**MONTROSE
PLANNING AND ZONING COMMISSION MEETING
AGENDA**

RE: Montrose – Preliminary Plat for Northridge 6th Addition

RE: Northridge 6th Addition - Preliminary Plat
Montrose, Minnesota
Project No.: 0W1.126364

We have reviewed the Preliminary Plat and Preliminary Construction Plans dated 1/12/2022 and have the following comments.

Northridge 6th Addition Preliminary Plat.

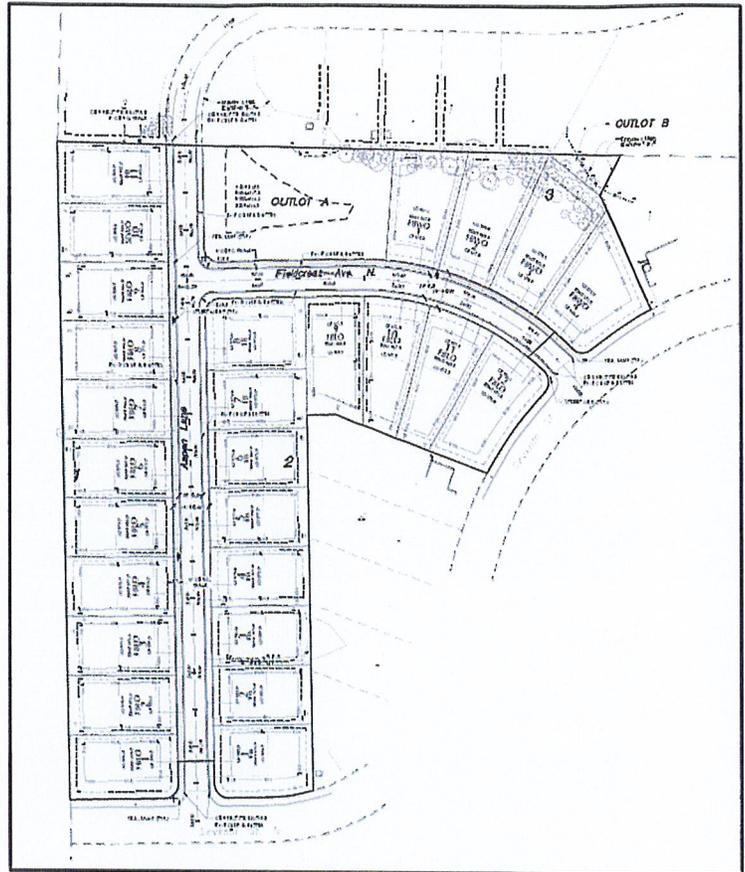
The proposed subdivision consists of 27 proposed lots, in the same manner as the original Preliminary Plat, which had expired over time. The applicant illustrates home sites on each of the 27 parcels, consistent with the City's R-1 zoning regulations, which require lots of 10,000 square feet in area and 75 feet of width. Setbacks are shown to be consistent with the requirements for 25 feet front, 10 feet side, and 20 feet rear.

The lots show a combination of lookout and walkout designs along the west side of Aspen Lane, with full basement lots along the east side of Aspen. The easterly extension of Fieldcrest Avenue show full-basement walkouts and lookouts.

However, it would appear that the west side of Aspen Lane, which is designed to have a combination of lookout and walkout house designs create a large part of the resultant tree loss. Exploring the option of lowering these buildings to full basement designs can sometimes have less impact on rear-lot grading. This option may save more of the existing tree cover – although it is noted in this plan that the grading plan is designed to direct stormwater to a series of rear catch basins, so this option could raise other issues with the project.

Secondarily, the rear-yard planting on many of the lots along the west of Aspen and the north of Fieldcrest have only limited tree planting, where much of the tree removal is occurring. Increasing tree planting in these rear areas could make up a portion of the gap.

Finally, front yard planting for the project is shown to be a single tree per lot. The Subdivision Ordinance provides for two trees per lot, and with 75 feet of lot width, this planting plan should be attainable.

1. The applicant works with the City staff and consultants on amending grading in the plat to further reduce tree loss and the attendant replacement requirements.

2. The applicant increases replacement planting in accordance with the comments in this report and where available as a part of revisions to the grading plan noted above.

3. The applicant provides additional replacement tree planting not possible in the proposed plat in accordance with the Subdivision Ordinance noted above, including either or both tree planting in eligible off-site locations and/or cash payments according to city policy and ordinances.

TREE PRESERVATION PLAN

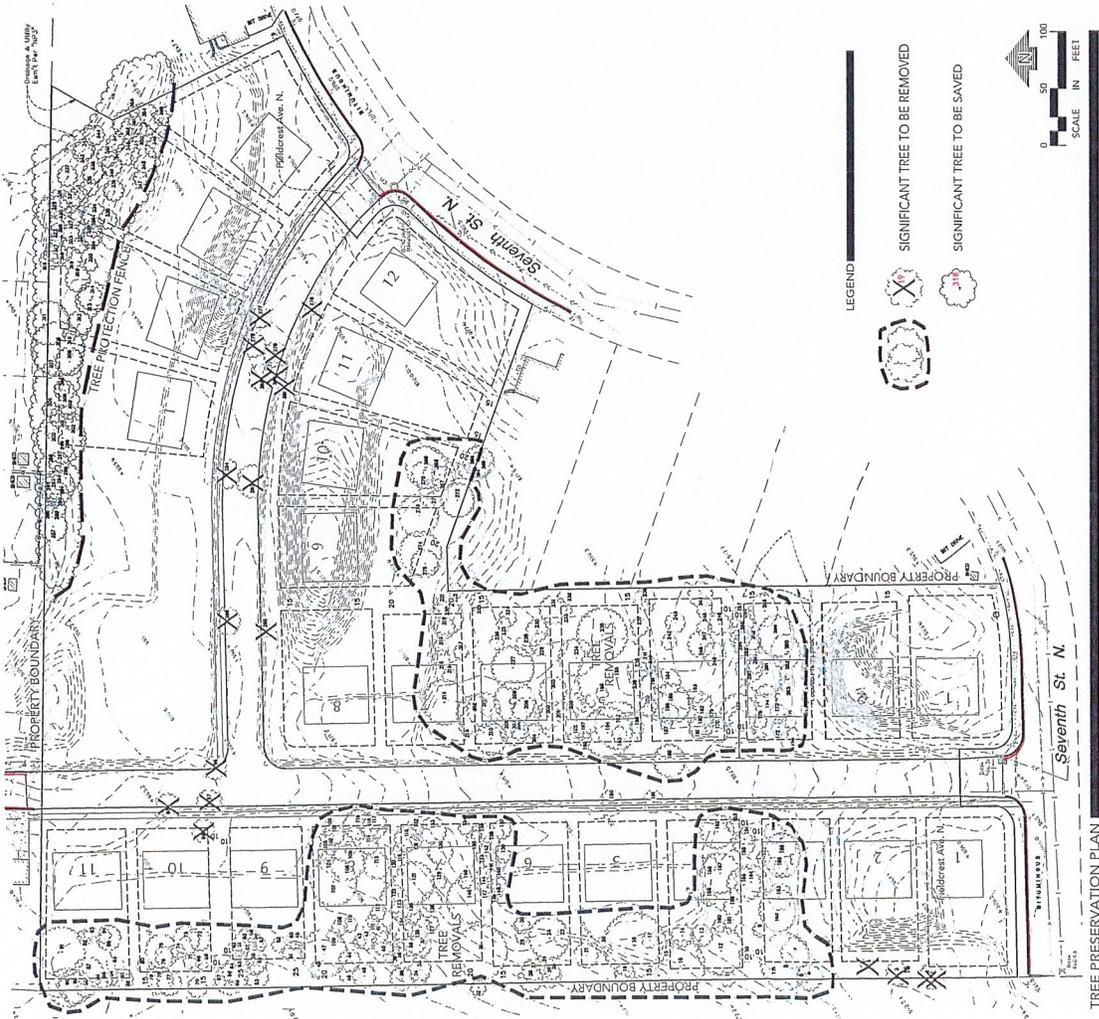
A significant amount of tree cover is impacted by the proposed plat. The City's Subdivision Ordinance allows 50% of the trees on a subdivision property to be removed for development activity. When more than 50% are removed, the additional removals are to be replaced at a 1.5 caliper inch replanting rate per 1.0 caliper inches removed.

For this project, the applicant's survey summary indicates that 81% of the caliper inches of existing trees are being removed, resulting in excess above the 50% threshold of 1,353 caliper inches of tree removal. This results in a required replacement of 2,031 caliper inches of new tree planting. At a typical size of 2.5 caliper inches at the time of planting, this would result in a replacement requirement of approximately 812 newly planted trees.

The proposed landscaping plan shows a planting plan of 104 new trees, or 260 caliper inches. The Subdivision Ordinance establishes two alternative replacement options for excess removal. That clause reads as follows:

In planning staff's estimation, there are three factors that may be considered, given the extensive requirements for replacement planting. First, due to the nature of the property in question, there is a significant amount of tree cover that is inevitably going to be lost for street construction, house pad grading, and the associated lot and stormwater grading necessary.
